**PREVOST**

**WARRANTY  
BULLETIN**

**WB15-39**

DATE :	OCTOBER 2015	SECTION :	18 - BODY
EXPIRATION:	OCTOBER 2017		
SUBJECT :	H3 VIP Entrance Door Improvement

Fig.1

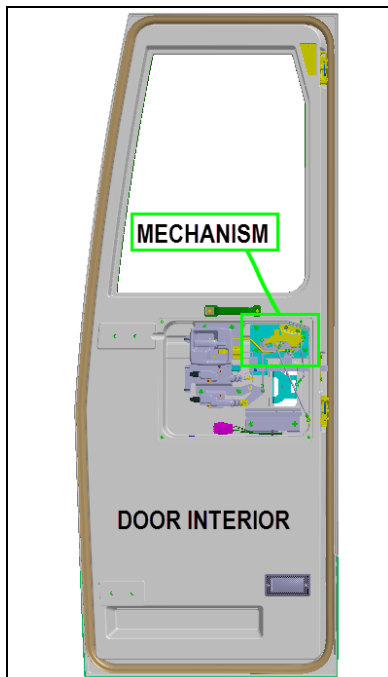
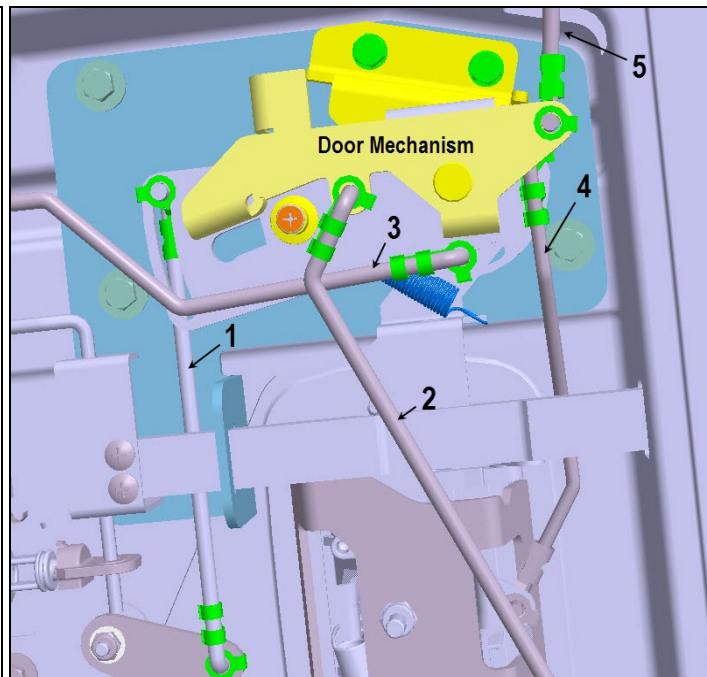
On the vehicles affected by this bulletin, the entrance door locking mechanism may occasionally fail to function properly and stay in the locked position, hindering the door opening.

1. Remove the door interior trim panel (This operation will vary from vehicle to vehicles depending on their configuration).
2. Locate the door locking mechanism and the five actuating rods connected to it (see Fig.1 and 2 below).

To prevent this situation, a new improved mechanism will be installed free of charge along with a reinforced actuating rod.

3. Disconnect rods # 2, 3, 4 and 5 identified above at the *door mechanism* end of the rods.

Fig.7

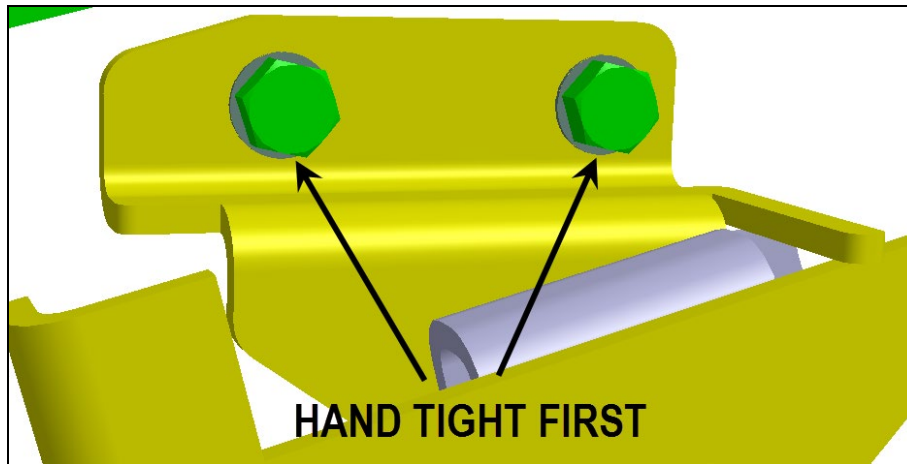
- Remove the two retaining bolts still holding the mechanism and remove it from the vehicle.
- Install the new mechanism on the vehicle door by first hand tightening the two retaining screws (Fig.7).

Fig.12

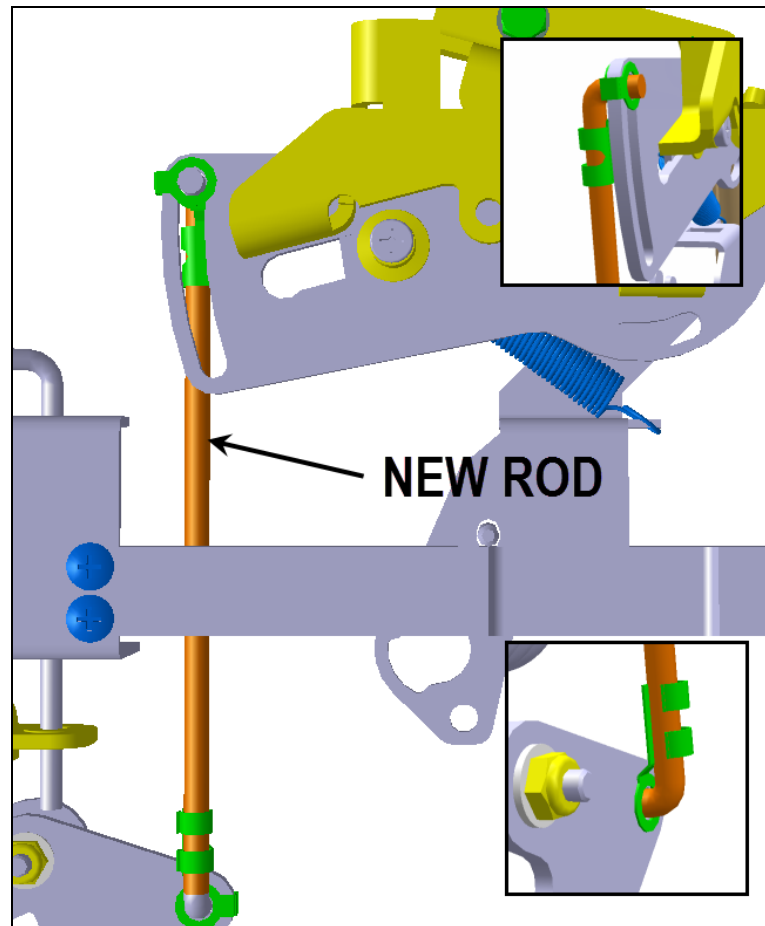
12. Install the new vertical actuating rod previously fitted with retaining clips (Fig.12)

Fig.13

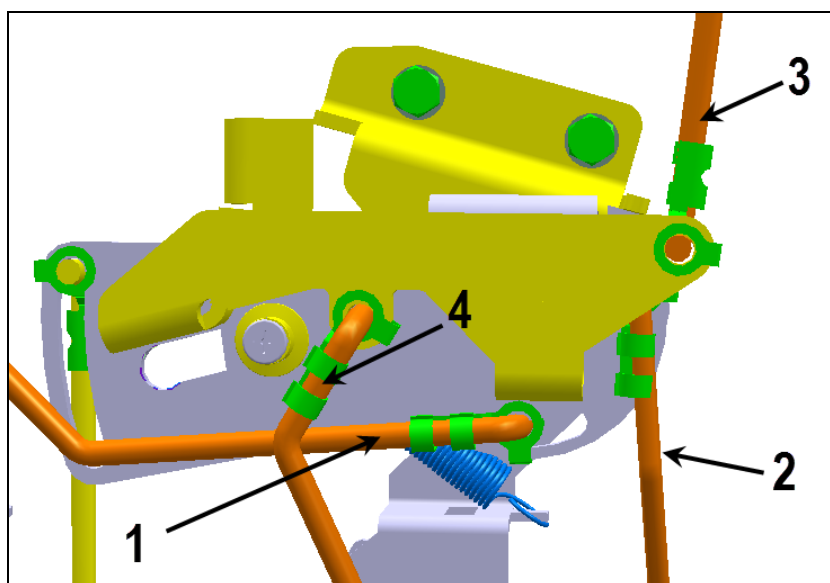
13. Reconnect the four remaining rods to the mechanism in the order shown below (Fig.13).
